Access Compliance Report

Public Rights-of-Way

Intersection ID: 53413	Main Street: GOLF_LINKS_DR	Cross Street: WAVERLY_WALK_AV	Location: E
ADA ID: 7C1E7D239735	Ramp Type: Perp	Initial Pass/Fail: Fail	Overall Compliance: No
			Severity Score: 21.25

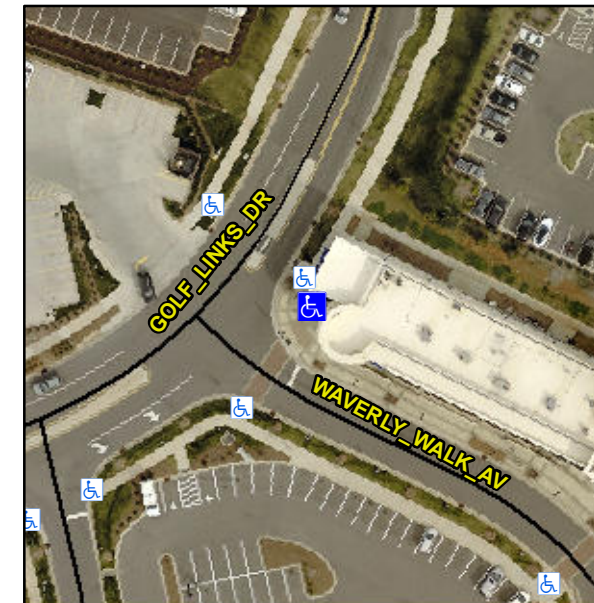
Not Found, R304.5.1, R304.2.2

Compliance	Description	Data	Compliance	Description	Data
N/A	Ramp Length (in)	63.0	No	Ramp Slope (%)	9.0
No	Ramp Width (in)	47.5	Yes	Ramp XSlope (%)	0.5
N/A	Flare Type LT	N/A	N/A	Flare Type RT	N/A
N/A	Flare Slope LT (%)	N/A	N/A	Flare Slope RT (%)	N/A
N/A	Flare Traversable LT?	N/A	N/A	Flare Traversable RT?	N/A
N/A	Landing Length (in)	N/A	N/A	DWS Provided?	N/A
N/A	Landing Width (in)	N/A	N/A	DWS Contrast?	N/A
N/A	Landing Slope (%)	N/A	N/A	DWS Length (in)	N/A
N/A	Landing X Slope (%)	N/A	N/A	DWS Full Width?	N/A
N/A	Landing Curb? (Y/N)	N/A	N/A	DWS Offset (in)	N/A
N/A	Shared Landing?	N/A			
N/A	Gutter Ponding?	N/A	N/A	Gutter Slope (%)	N/A
N/A	Gutter Lip Ht (in)	N/A	N/A	Gutter X Slope (%)	N/A
N/A	Painted X Walk1?	Yes	N/A	Painted X Walk2?	N/A
	X Walk 1 Direction	To SW		X Walk 2 Direction	N/A
N/A	X Walk 1 Width (in)	104.0	N/A	X Walk 2 Width (in)	N/A
	X Walk 1 Slope (%)	2.0		X Walk 2 Slope (%)	N/A
	X Walk 1 X Slope (%)	1.5		X Walk 2 X Slope (%)	N/A

Remove & Replace Entire Ramp.
